***Interactive comment on* “The impact of uncertain precipitation data on insurance loss estimates using a Flood Catastrophe Model” by C. C. Sampson et al.**

Received and published: 22 April 2014

Response to comments from anonymous referee 1:

Fig. 1. Revised: Figure 5

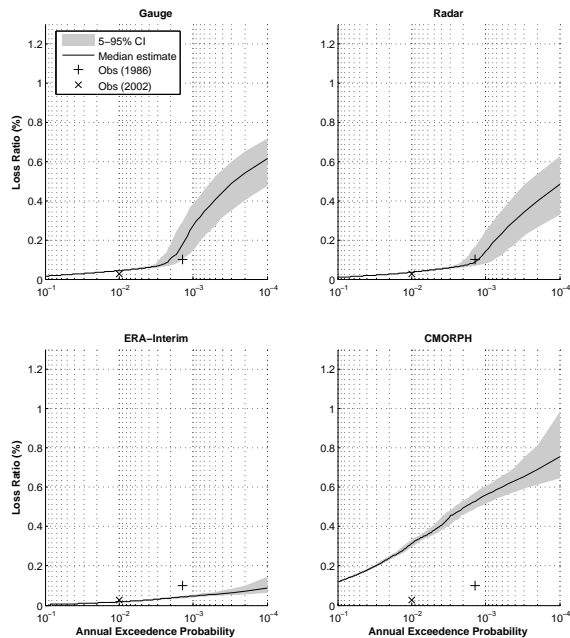
P78) Figures 5, 7 and 9 now gridded with consistent y-axis

We have uploaded the revised manuscript (see supplement) along with updated figures (5, 6, 7) and a new figure (9).

Fig. 4. New: Figure 9

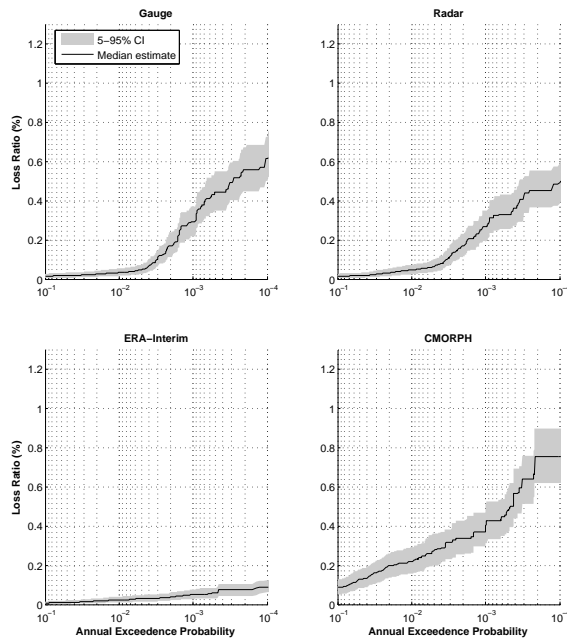
1) We have now incorporated vulnerability uncertainty into the paper. The relevant literature review has been extended slightly in section 1.3, the method is described in 2.2.3, the results are presented in 3.4 and the discussion and conclusions have been updated. A new figure (figure 9) has been added.

1) Vulnerability model uncertainty now included. See response to question 1 from referee 1.
